Name of Proposal: Oakmont (Oakhurst)

Review Type: Development of Regional Impact

Preliminary Report:	May 21, 2007	DEVELOPMENT OF REGIONAL IMPACT REVIEW REPORT	Project:	Oakmont (Oakhurst) #1366
Final Report Due:	June 20, 2007		Comments Due By:	June 4, 2007

COMPOSITE PLAN FOR:
OAKHURST
(FMA OAKMONT)
OAKLEY ROAD
LAND LOT 67, 6th DISTRICT
OF FULTON COUNTY, GEORGIA
1.482,304 sq. ft.
34.029 acres
US CENSUS TRACT:
131-21-010-610

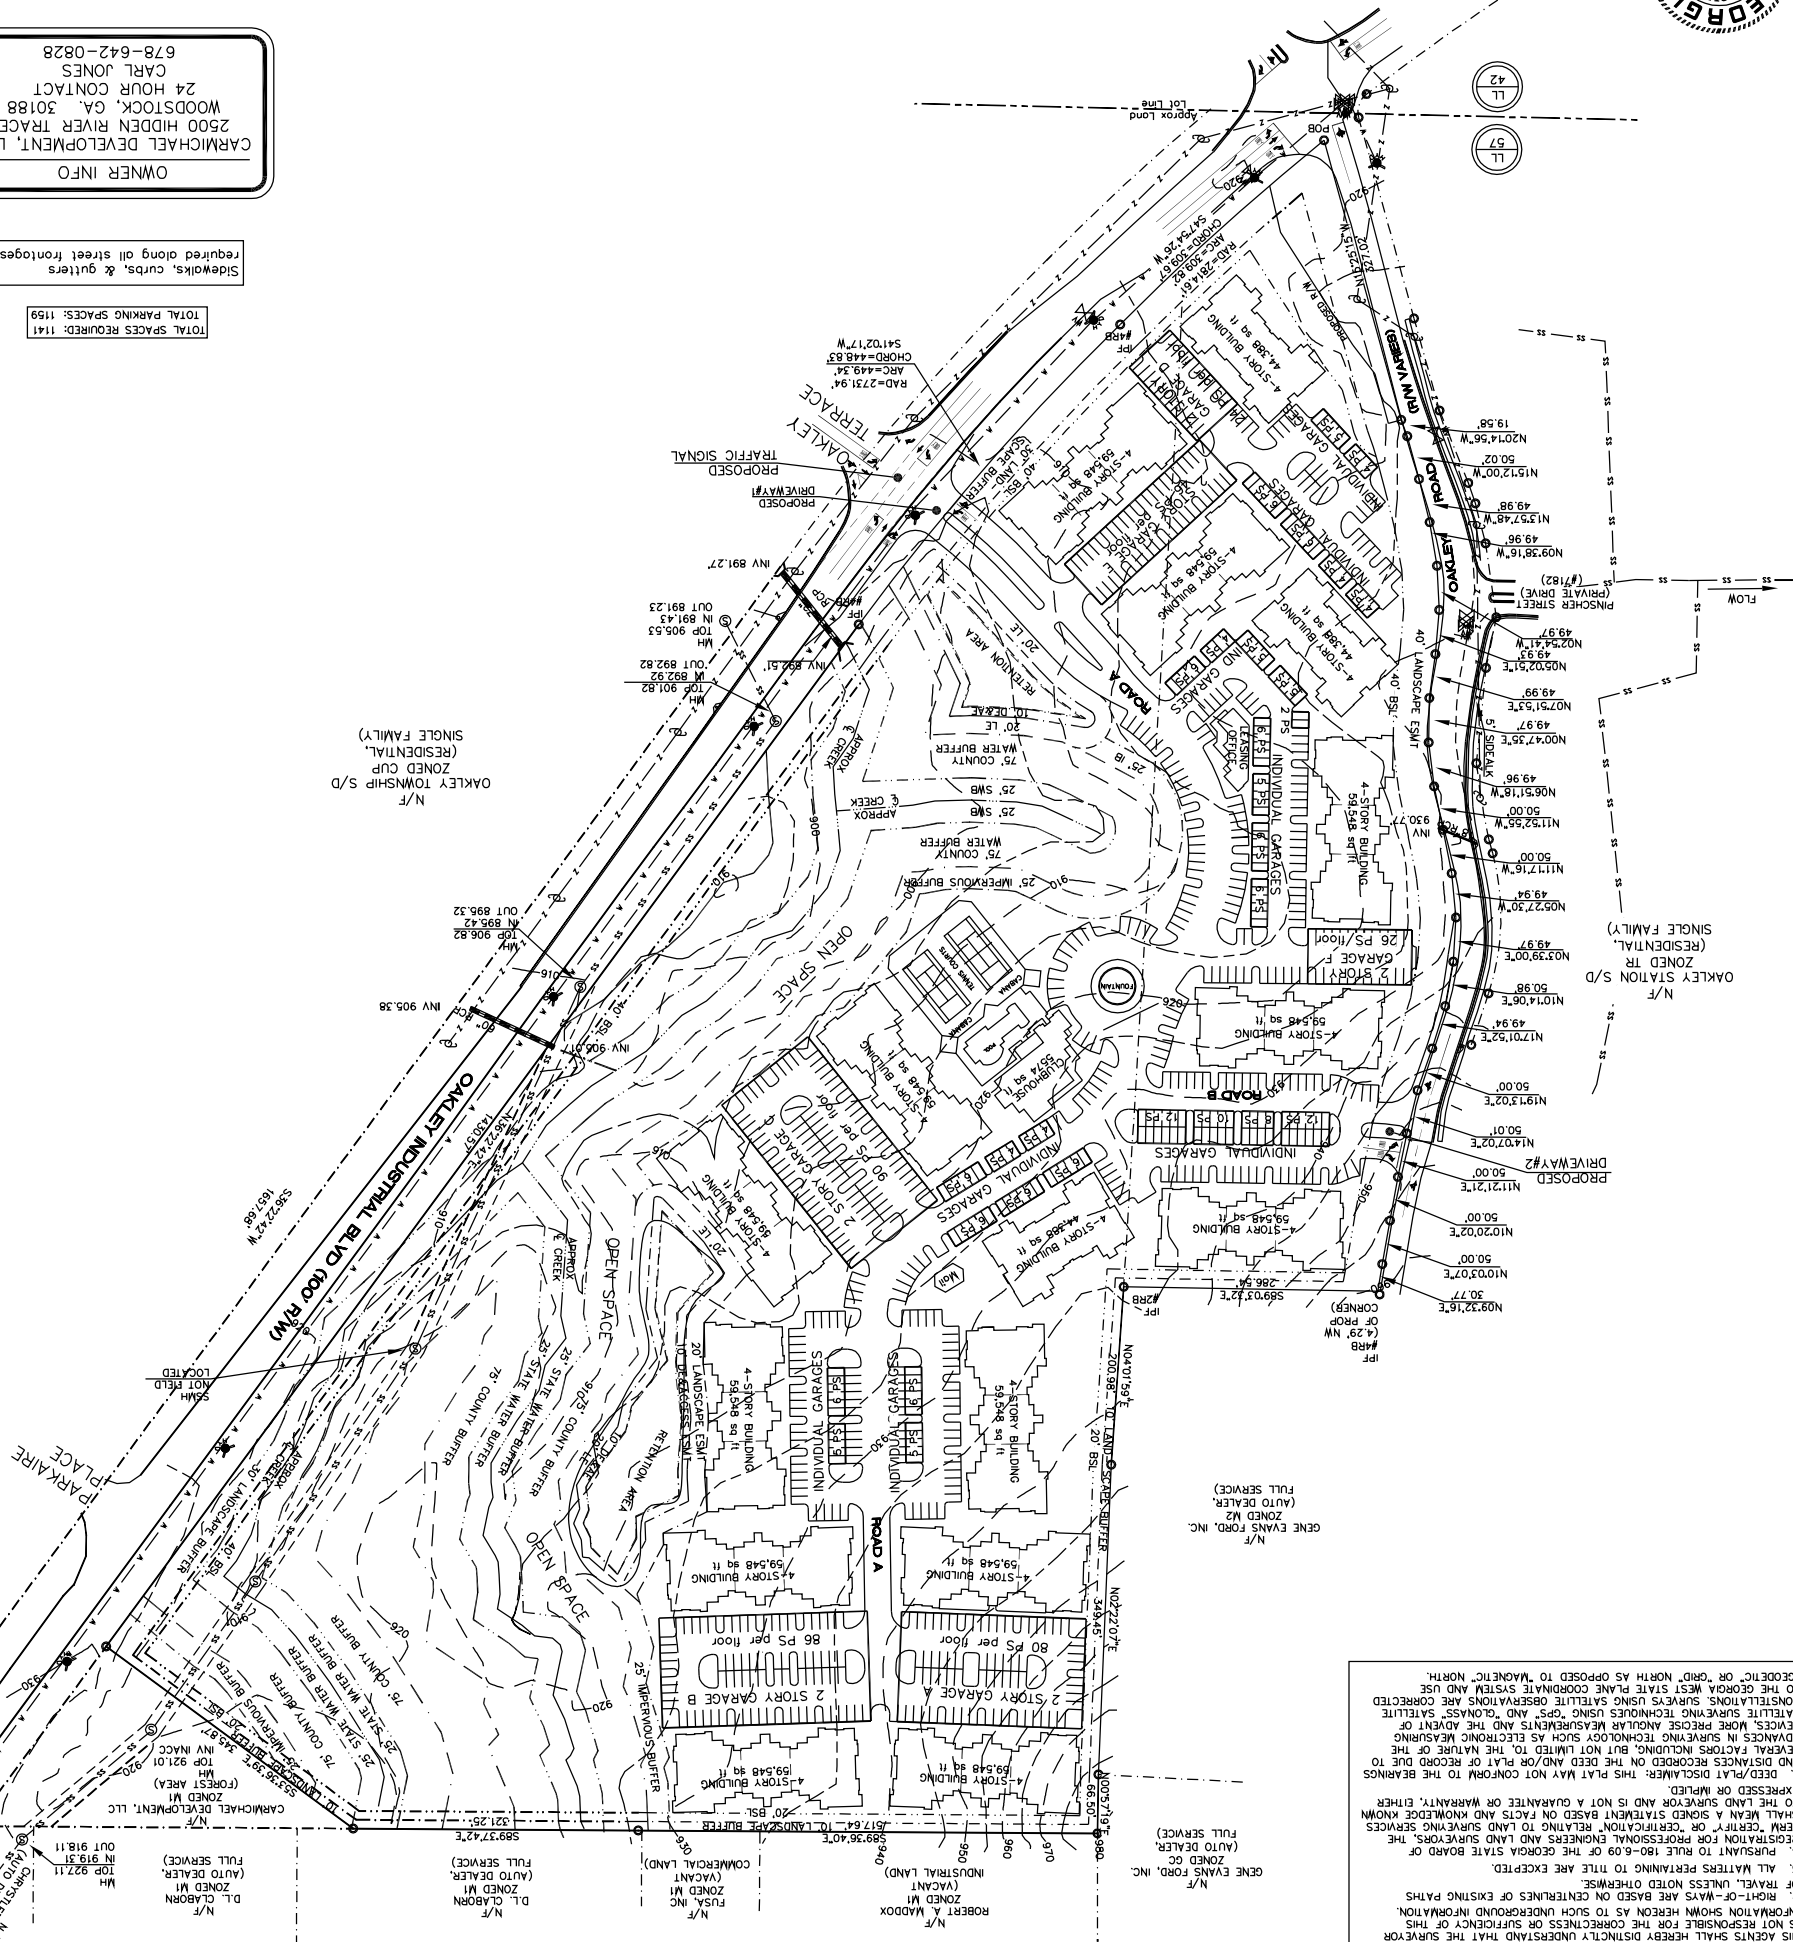
No streams are shown on USGS coverage for the project property. A stream is shown on the site plan with the required County 75-foot stream buffer and the State 25-foot Erosion and Sedimentation buffer. Any other waters of the state on the property will also be subject to the State 25-foot erosion and sedimentation buffer.
